CISPR/D/426A/RVC

RESULT OF VOTING ON CDV

Project number: CISPR 25 Ed. 4	Reference number of the CDV CISPR/D/425A/CDV
IEC/TC or SC CISPR/D	Date of circulation 2016-05-13

Vehicles, boats and internal combustion engines - Radio disturbance characteristics - Limits and methods of measurement for the protection of on-board receivers

Figure 8b – Average limit for radiated disturbance from vehicles GLONASS band
1 590,781 to 1 616,594 MHz

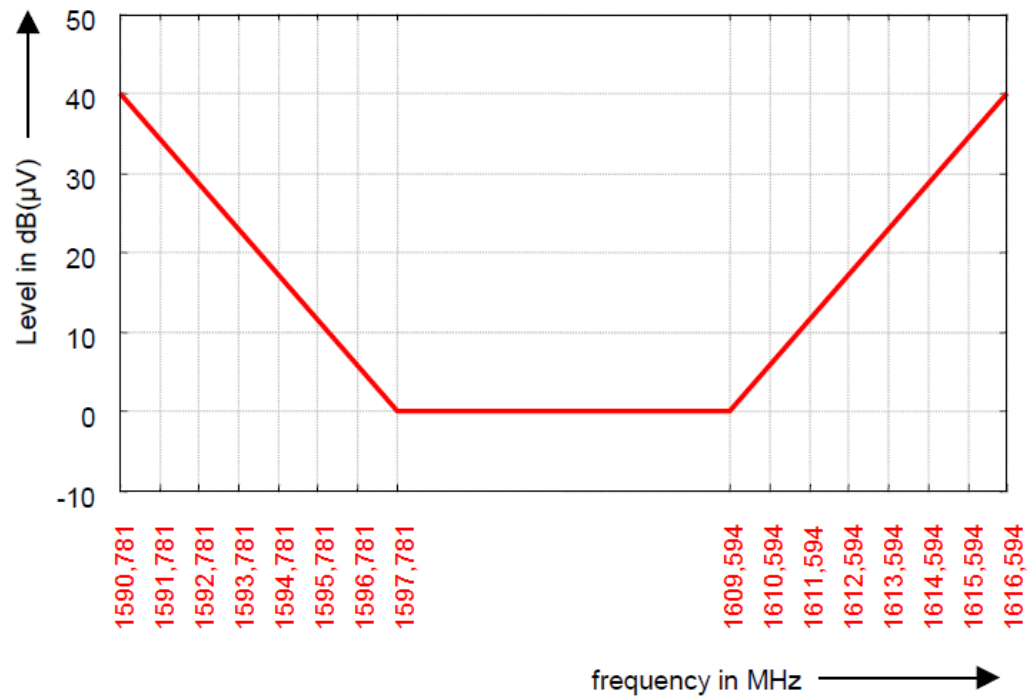
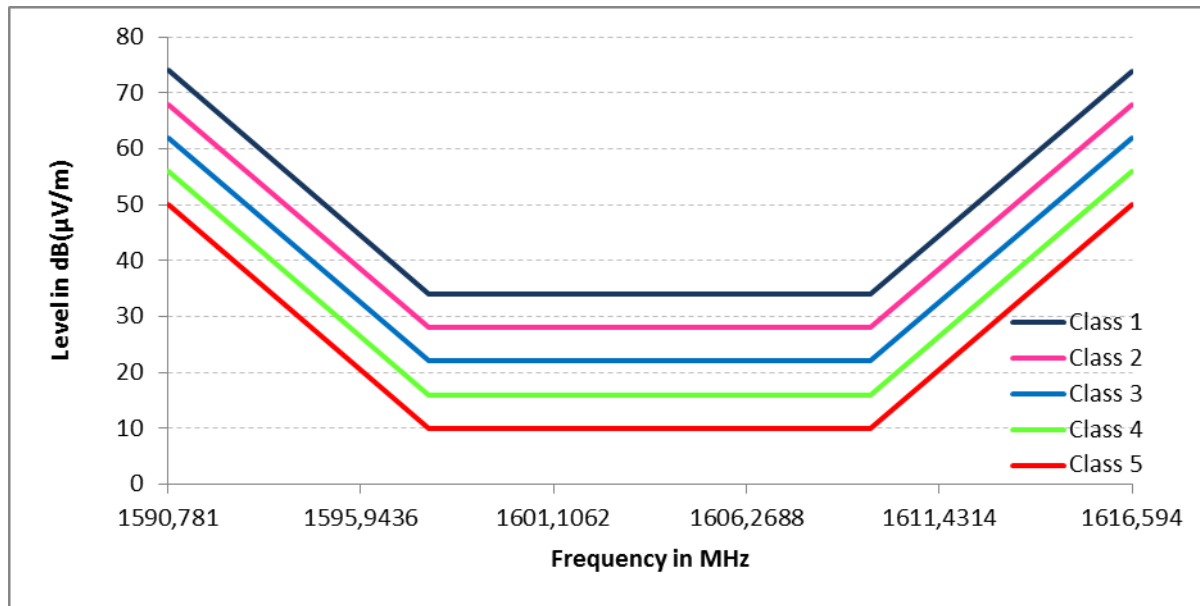
DE-24	793 1215	5.4 6.5.4	Fig. 8b Fig. 21b	Te	Today, all active GLONASS satellites are using L1-channels in the range from -7 to +6, The values in the figures represent L1-channels -7, +8, where the limit line (ramp area) cut the constant limit line on the center frequency of the lowest and the highest channel. Modern GLONASS-Receiver-Chips are designed to receive all L1-channels (-7..+13)	Modify the limit line figures to cover the latest GLONASS receiver technology and change figure title accordingly. (see annex)	agreed
US-10	804	5.4		ed	It appears that a "page break" is here.	Page Break should be removed	will be part of the final editing
GB19	810-811	6.1	Para 3	te	Is there a reason that Conducted Emission (Current Method) is not specified for LV/HV	Add another bullet regarding current method as appropriate.	agreed

Limit for the protection of GLONASS receivers

Annex on FR-45 :

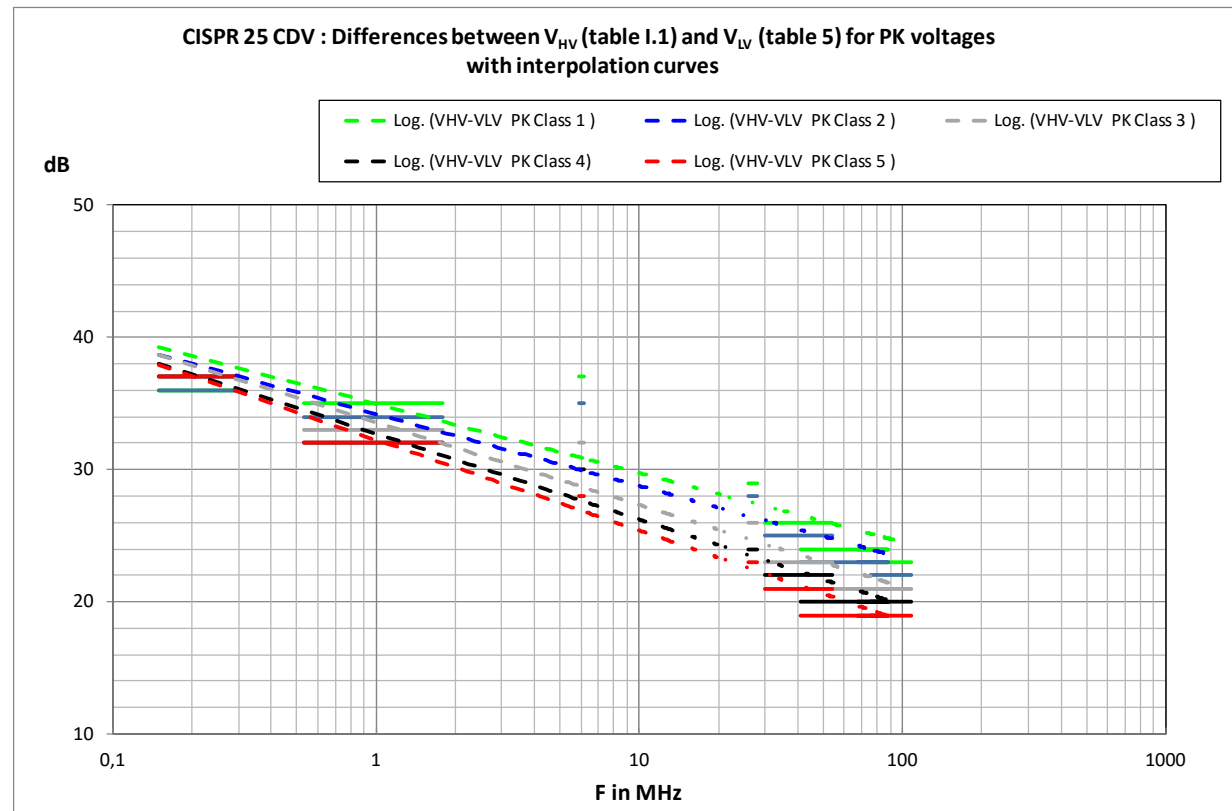
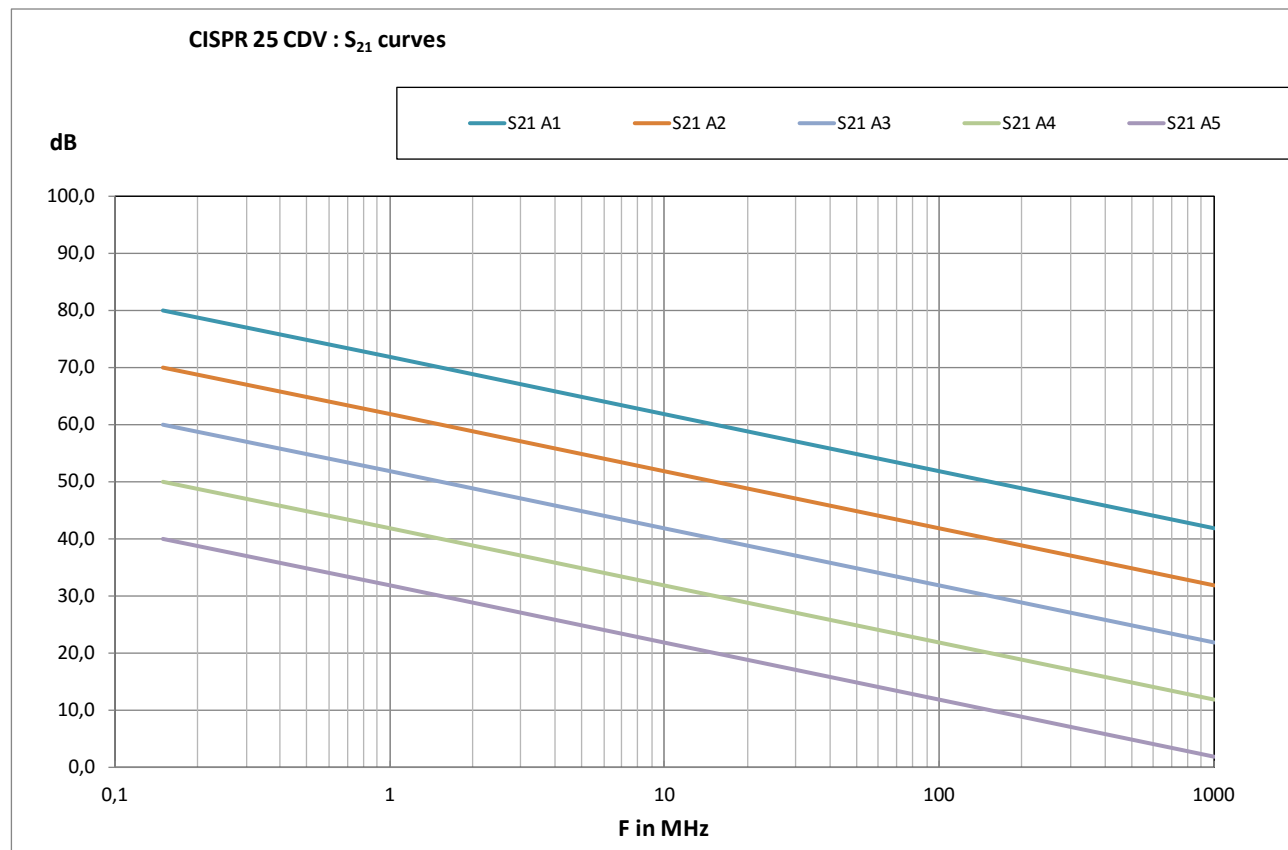
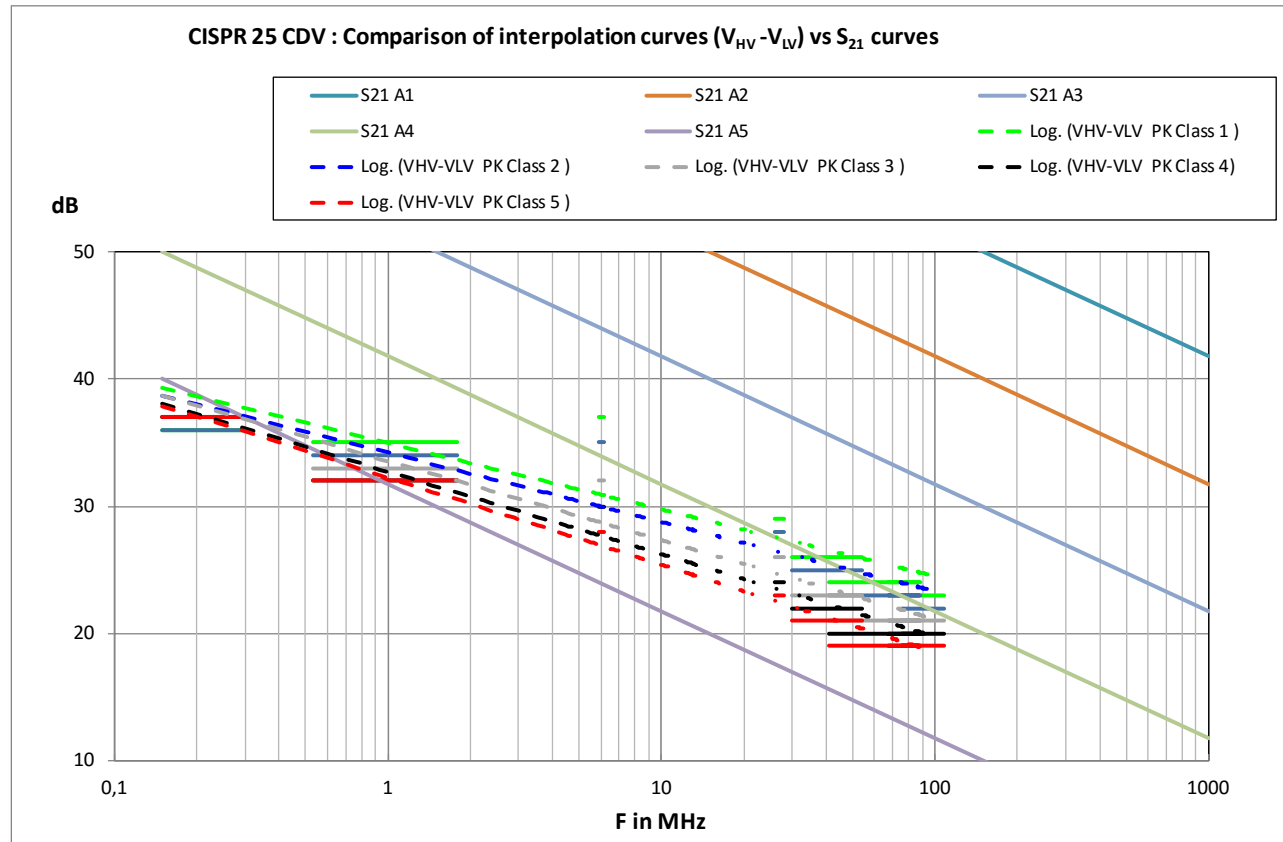
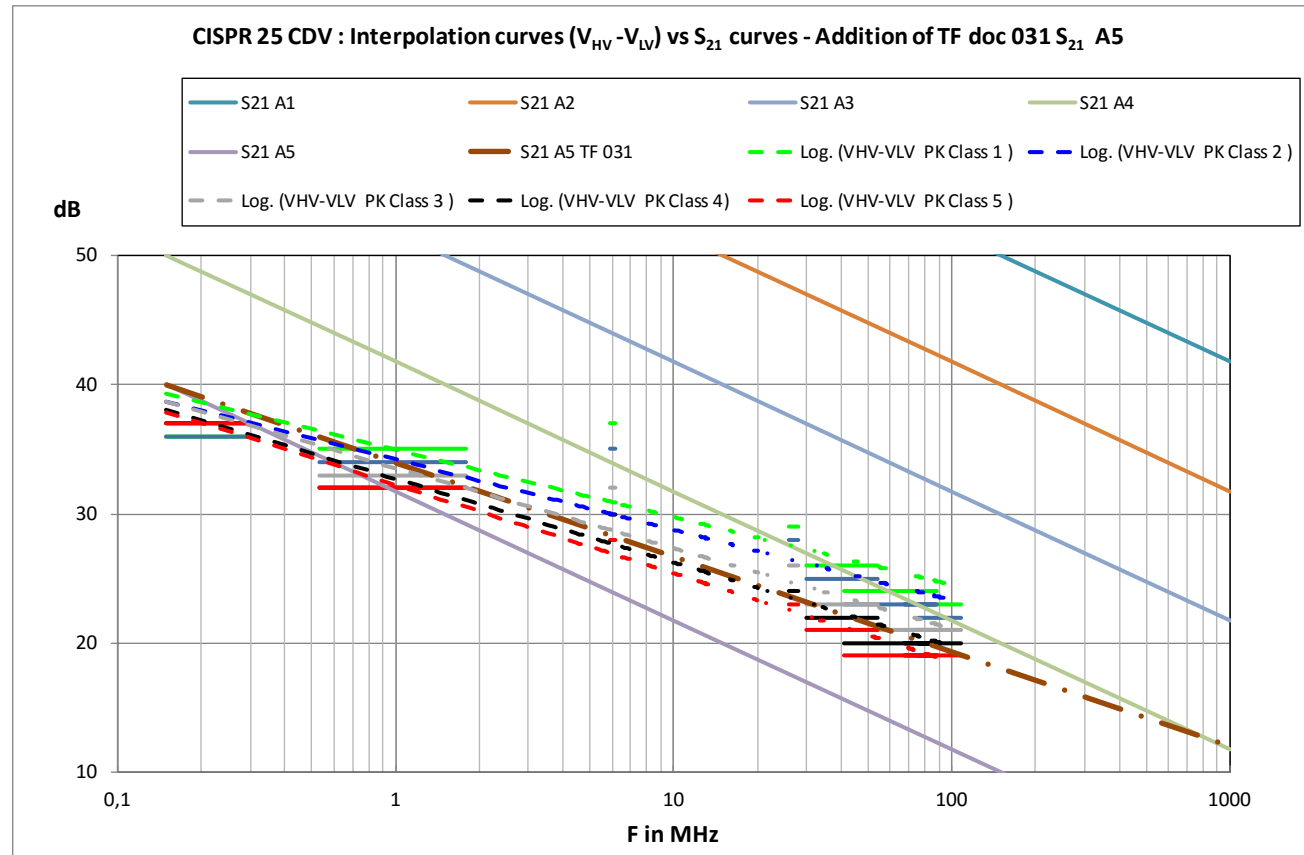
MB/N C	Line number (e.g. 17)	Clause/ Subclause (e.g. 3.1)	Paragraph/ Figure/ Table/ (e.g. Table 1)	Type of comment	Comments	Proposed change	Observations of the secretariat
FR-45	2058 to 2065	I.2.3		te	<p>All the wording seems to explain that limits in Table I.1 have been "calculated" from Table 5 and one of the decoupling factor (A.1 to A.5) of Table I.4.</p> <p>A comparison between Table I.1 and Table 5 for class 5 gives the following differences :</p> <p>LW : 37 dB</p> <p>MW : 32 dB</p> <p>SW : 28 dB</p> <p>FM : 19 dB</p> <p>TV band I : 19 dB</p> <p>CB : 23 dB</p> <p>VHF 1 : 21 dB</p> <p>VHF 2 : 19 dB</p> <p>The differences in LW is close to the value isolation A.5 (40 dB) when the difference in FM is close to the value isolation A.4 (21 dB). Therefore the consistency is not valid for the whole frequency range.</p> <p>This may come from the fact that during the TF discussions there has been various proposals for isolation curves (the HV limit table in this document may have issued from a previous TF document isolation curves).</p> <p>For example the curve A.5 of TF_doc_031 is very close to the above calculated differences.</p> <p>Furthermore it is not clear if all HV classes have been derivated from 12 V classes with the same isolation curve (Ax) or if class 5 of HV table has been derivated from class 5 of 12 V table with one isolation curve Ax and then class 1 to 4 from HV table correspond</p>	<p>Consistency between wording and Table 5, Table I.1 and Table I.4 should be checked and then wording and/or Tables should be updated consequently.</p> <p>See Annex on FR-45 at the end of the document after the table of comments</p>	<p>agreed with modification</p> <p>Table will be updated per French proposal made at the WG2 meeting</p>

This figure shows that the differences are not identical for the 5 classes and that the differences are also not consistent for the various sub-bands

This figure shows that the differences for the various classes are not identical (rough data) and furthermore that the interpolated data are not identical and do not have the same slope.

The differences and the slopes of the various CISPR 25 CDV S_{21} data are consistent.

This figure shows that the S_{21} data proposed in CISPR 25 CDV and the interpolated differences between Conducted emission on LV power lines and Conducted emission on HV power lines are not consistent in terms of values and of slopes (interpolation is close to S_{21} A5 at 150 kHz when it is close to S_{21} A4 at 108 MHz)

This figure shows that the slopes of interpolated differences data and of the TF_031 S_{21} A5 data seem quite identical. Therefore the present CISPR 25 table I.1 (for HV lines) may have been issued from CISPR 25 table 5 (for LV lines) using a previous version of S_{21} from an earlier TF document which may explain some of the questions raised in this French comment about Table I.1 and S_{21} values in the present CDV document.

Frequency range 150 kHz – 30 MHz

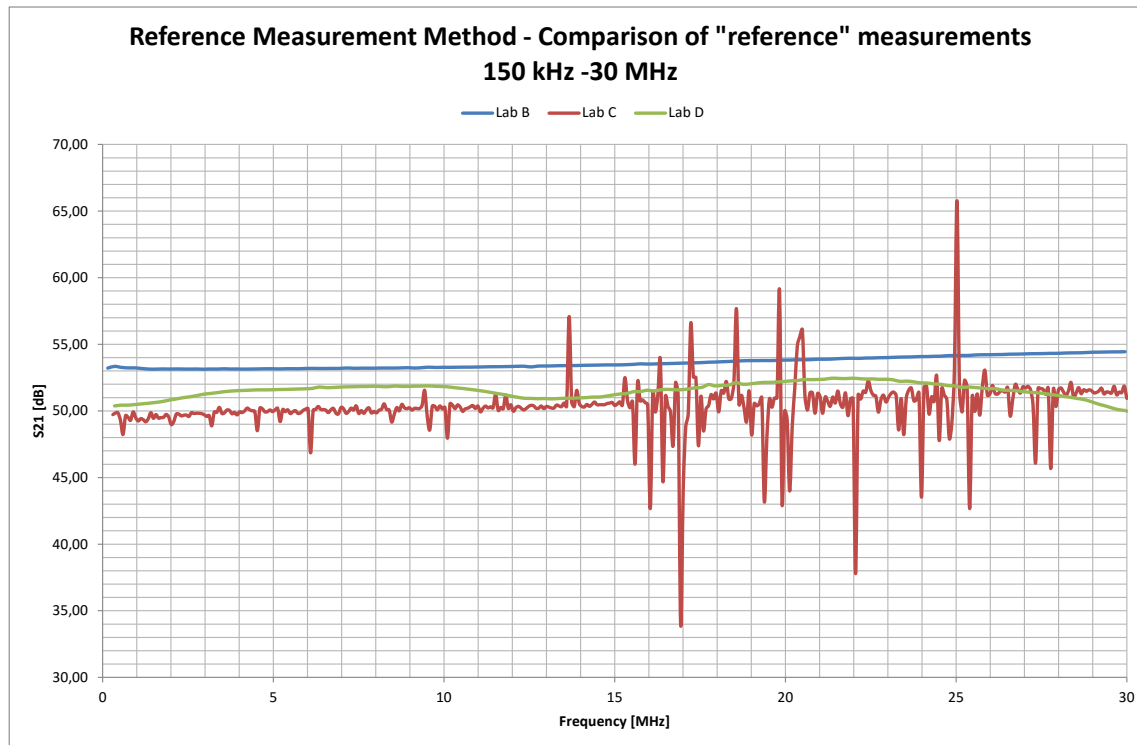
The following graph presents the « reference » measurements for 3 different laboratories

These measurements show that for only 3 different laboratories, differences up to 3 dB can be observed (variation shown for Lab C due to noise environment are not considered for deviation evaluation)

Frequency range 30 MHz – 1000 MHz Vertical polarisation

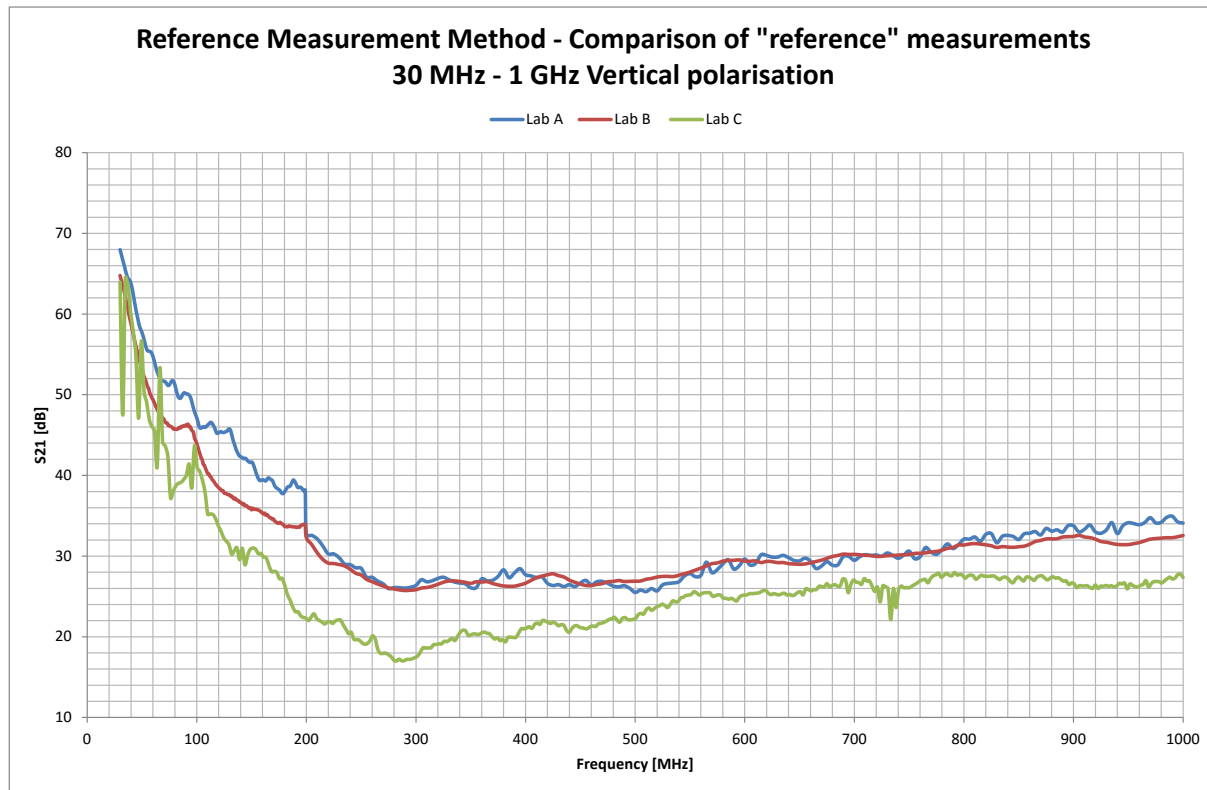
The following graph presents the « reference » measurements for 3 different laboratories

These measurements show that for only 3 different laboratories, differences from 3 to 10 dB can be observed

Frequency range 30 MHz – 1000 MHz Horizontal polarisation

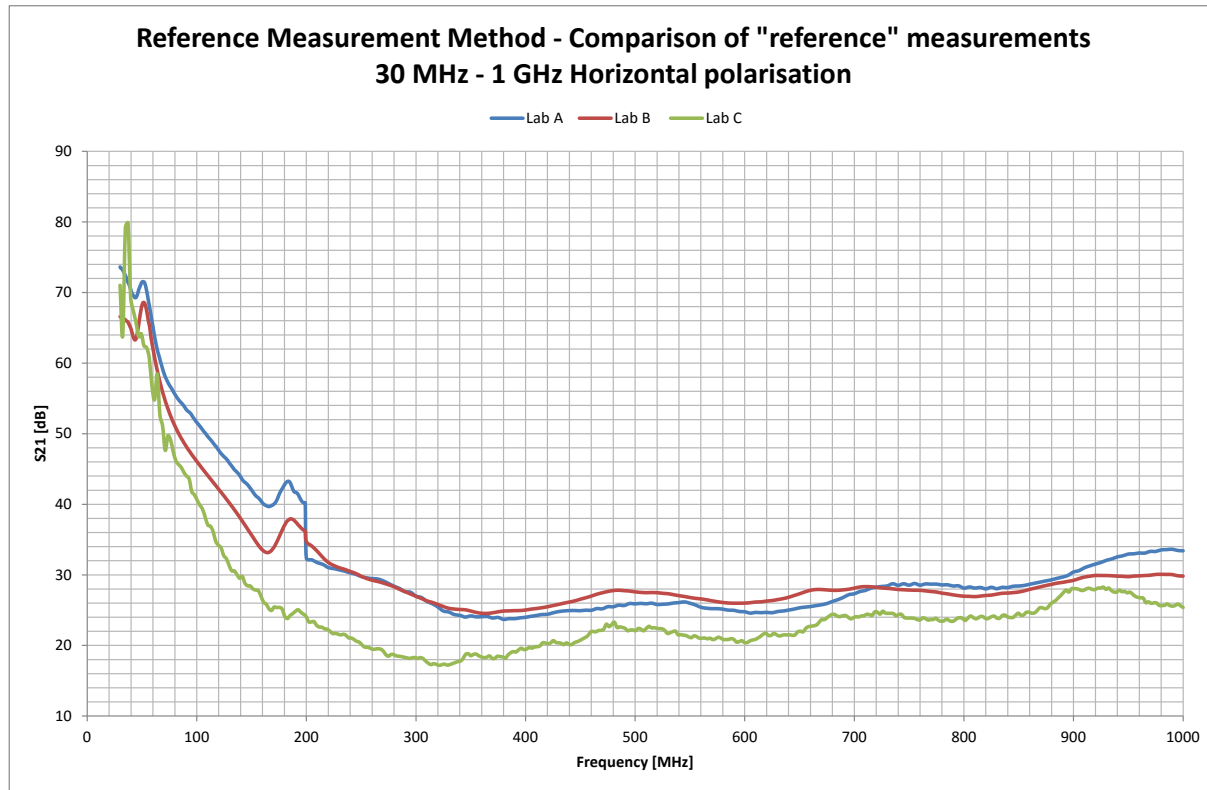
The following graph presents the « reference » measurements for 3 different laboratories

These measurements show that for only 3 different laboratories, differences from 4 to 16 dB can be observed
